Access Compliance Report

Public Rights-of-Way

(Curb Ramps)

Intersection ID: 29970	Main Street: BROAD RIDGE CT	Cross Street: CANIPE DR	Location: S
ADA ID: 6859FE26E869	Ramp Type: PerpDiag	Initial Pass/Fail: Fail	Overall Compliance: No
Severity Score: 10			
Codes/Mitigation Info/Possible Solution		Field Measurements/Component Compliance

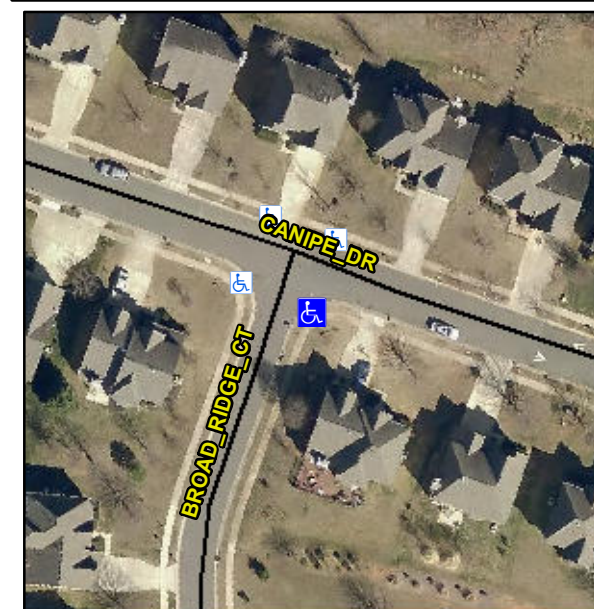
R304.5.1, R304.5.3

Compliance	Description	Data	Compliance	Description	Data
N/A	Ramp Length (in)	50.0	Yes	Ramp Slope (%)	6.9
No	Ramp Width (in)	37.0	No	Ramp XSlope (%)	2.9
N/A	Flare Type LT	N/A	N/A	Flare Type RT	N/A
N/A	Flare Slope LT (%)	N/A	N/A	Flare Slope RT (%)	N/A
N/A	Flare Traversable LT?	N/A	N/A	Flare Traversable RT?	N/A
N/A	Landing Length (in)	N/A	N/A	DWS Provided?	N/A
N/A	Landing Width (in)	N/A	N/A	DWS Contrast?	N/A
N/A	Landing Slope (%)	N/A	N/A	DWS Length (in)	N/A
N/A	Landing X Slope (%)	N/A	N/A	DWS Full Width?	N/A
N/A	Landing Curb? (Y/N)	N/A	N/A	DWS Offset (in)	N/A
N/A	Shared Landing?	N/A			
N/A	Gutter Ponding?	N/A	N/A	Gutter Slope (%)	N/A
N/A	Gutter Lip Ht (in)	N/A	N/A	Gutter X Slope (%)	N/A
N/A	Painted X Walk1?	No	N/A	Painted X Walk2?	No
	X Walk 1 Direction	To N		X Walk 2 Direction	To W
N/A	X Walk 1 Width (in)	N/A	N/A	X Walk 2 Width (in)	N/A
	X Walk 1 Slope (%)	0.5		X Walk 2 Slope (%)	0.4
	X Walk 1 X Slope (%)	7.0		X Walk 2 X Slope (%)	6.5

Remove & Replace Curb Ramp With Two New Directional Ramps or Equivalent.
